June 21, 2021

City of Pasadena Design Commission
Attn: Michi Takeda
Pasadena City Hall
100 N. Garfield Avenue
Pasadena, CA 91101

Re: Central District Specific Plan – Round 3

Pictured: In many instances, existing towers greatly exceed the proposed zoning.

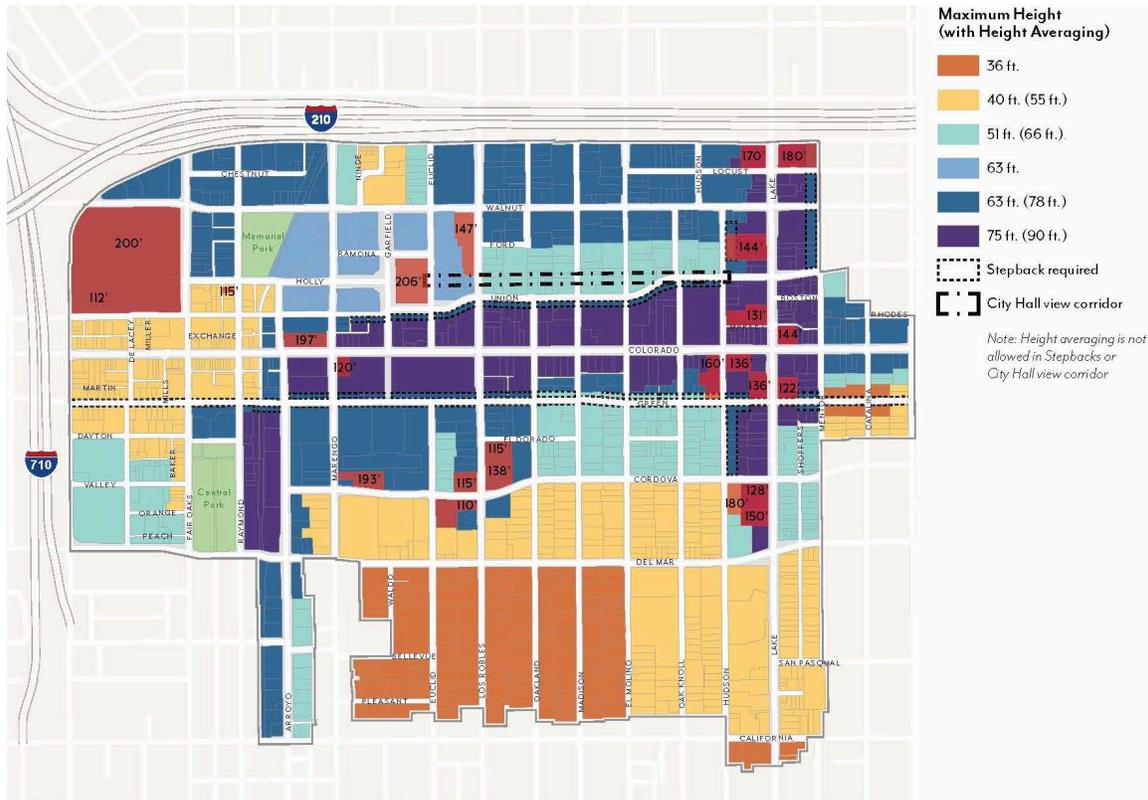
An important piece of information is missing and needed in the plan to support the proposed heights. An overlay map of existing heights, as opposed to what is proposed is needed. In historic districts, where heights are usually one to three stories, only a modest upzoning is appropriate. In more newly developed areas where high rises dominate, restricting development to midrise seems counterproductive.
